Access Compliance Report

Public Rights-of-Way

(Curb Ramps)

Intersection ID: 10038639	Main Street: ST_JOHN_LN	Cross Street: N/A	Location:	N
ADA ID: A935D14C5119	Ramp Type: BlendTrans1	Initial Pass/Fail: Fail	Overall Compliance: No	Severity Score: 8.75
Codes/Mitigation Info/Possible Solution		Field Measurements/Component Compliance

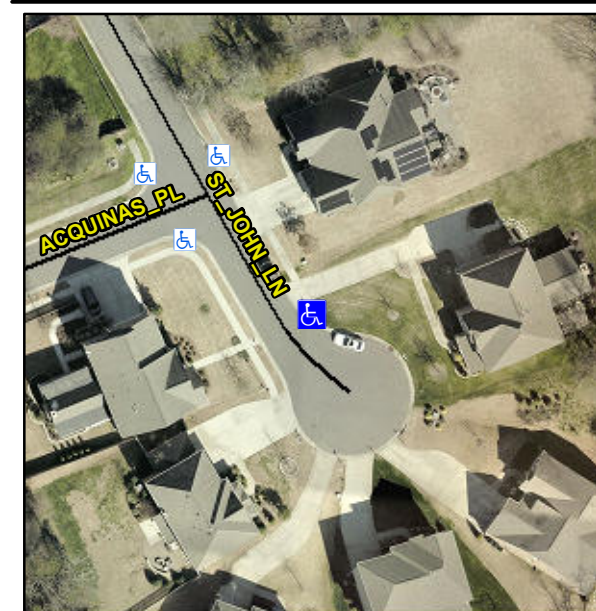
CURB LIP 0.5

Not Found, R304.5.1

Compliance	Description	Data	Compliance	Description	Data
N/A	Ramp Length (in)	47.0	Yes	BlendTrans Slope (%)	3.8
No	Ramp Width (in)	47.0	Yes	BlendTrans XSlope (%)	1.8
N/A	Flare Type LT	N/A	N/A	Flare Type RT	N/A
N/A	Flare Slope LT (%)	N/A	N/A	Flare Slope RT (%)	N/A
N/A	Flare Traversable LT?	N/A	N/A	Flare Traversable RT?	N/A
N/A	Landing Length (in)	N/A	N/A	DWS Provided?	N/A
N/A	Landing Width (in)	N/A	N/A	DWS Contrast?	N/A
N/A	Landing Slope (%)	N/A	N/A	DWS Length (in)	N/A
N/A	Landing X Slope (%)	N/A	N/A	DWS Full Width?	N/A
N/A	Landing Curb? (Y/N)	N/A	N/A	DWS Offset (in)	N/A
N/A	Shared Landing?	N/A			
N/A	Gutter Ponding?	N/A	N/A	Gutter Slope (%)	N/A
N/A	Gutter Lip Ht (in)	N/A	N/A	Gutter X Slope (%)	N/A
N/A	Painted X Walk1?	No	N/A	Painted X Walk2?	N/A
	X Walk 1 Direction	To SW		X Walk 2 Direction	N/A
	X Walk 1 Width (in)	N/A		X Walk 2 Width (in)	N/A
	X Walk 1 Slope (%)	2.6		X Walk 2 Slope (%)	N/A
	X Walk 1 X Slope (%)	3.4		X Walk 2 X Slope (%)	N/A

N/A	Ramp inside XWalk1?	N/A	N/A	Ramp inside XWalk2?	N/A
	Road Slope (%)	3.4		Clear Space?	N/A
	Road X Slope (%)	2.6	N/A	Clear Space to XWalk (in)	N/A
N/A	Any Obstructions?	N/A	N/A	Storm Grate/Utility Hazard?	N/A
	Obstruction Type			Storm Grate/Utility Type	
		N/A			N/A
			Yes	Surface Condition? (G/P)	Good
			No	Curb Slope (%)	11.6

Remove & Replace Curb Ramp With Two New Directional Ramps or Equivalent.
